32ND AVENUE (HIGHLANDS CREEK BLVD TO TAH PARKWAY) AT THE AURORA HIGHLANDS

OVERALL SITE PLAN

32ND AVENUE (HIGHLANDS CREEK BLVD TO TAH PARKWAY)
AT THE AURORA HIGHLANDS
GRADING & UTILITY PLAN

32ND AVENUE (HIGHLANDS CREEK BLVD TO TAH PARKWAY)
AT THE AURORA HIGHLANDS
LIGHTING PLANS
DATE: JANUARY 21, 2022

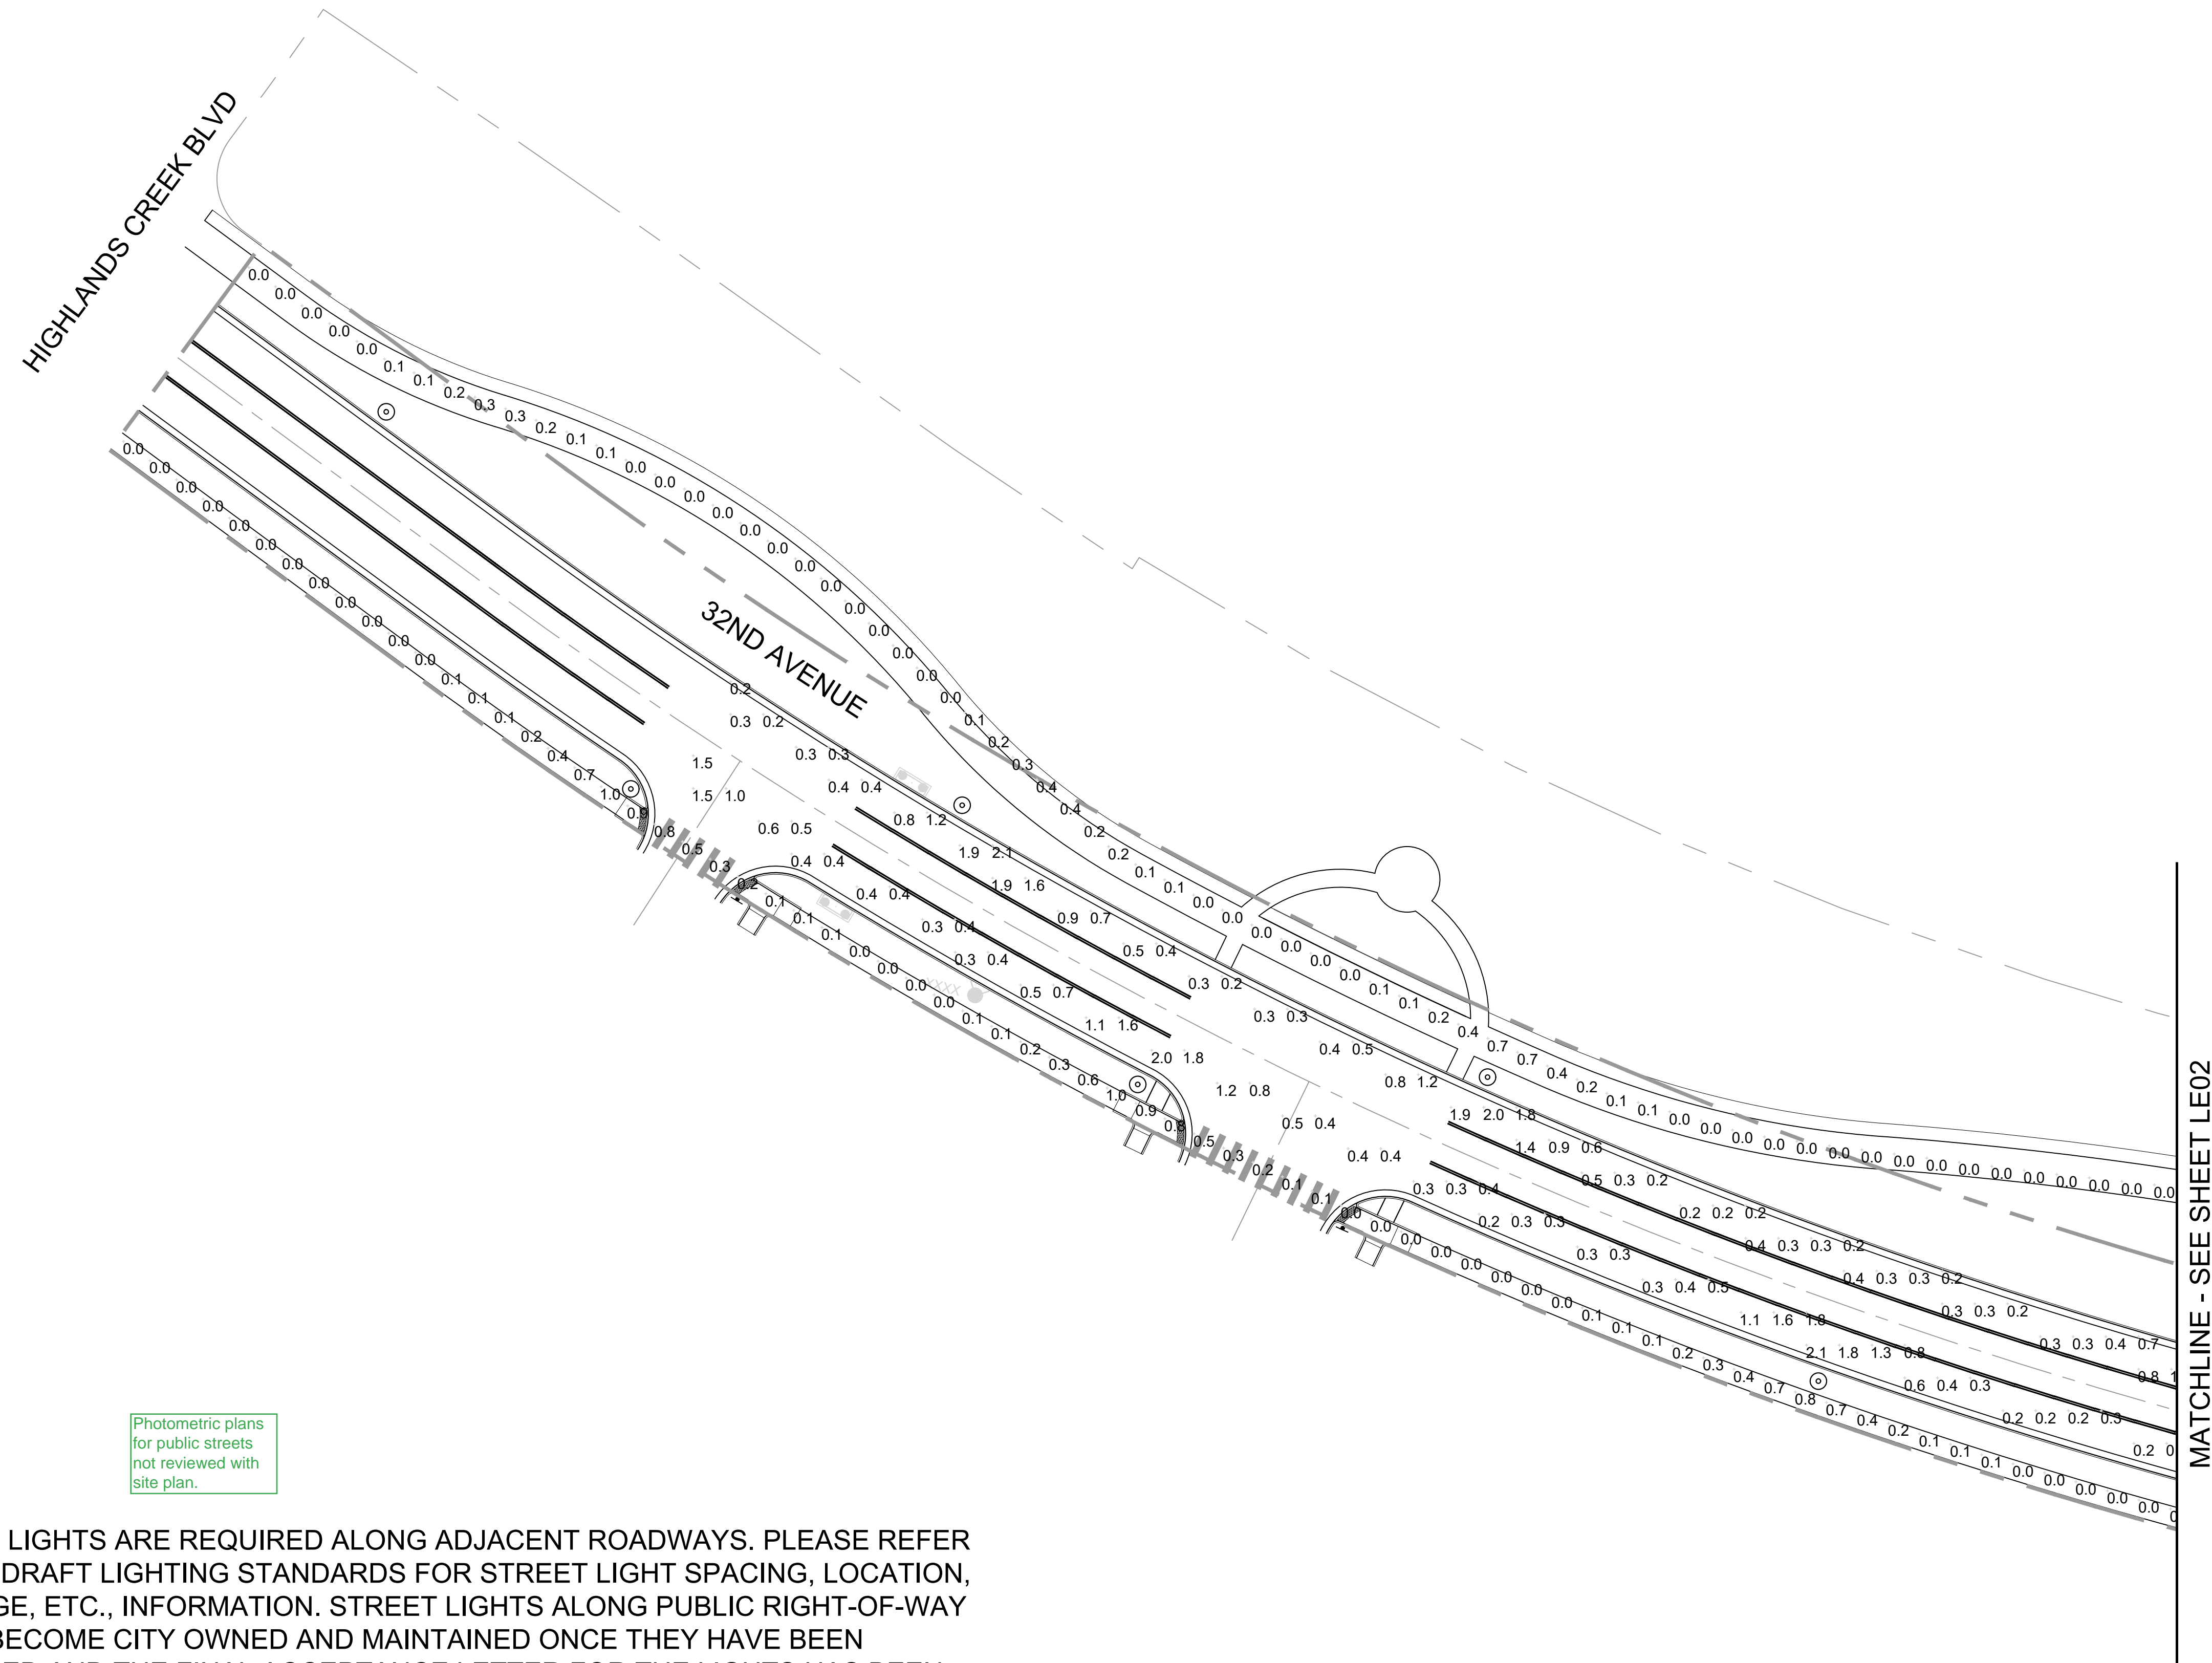
Photometric plans
for public streets
not reviewed with
site plan.
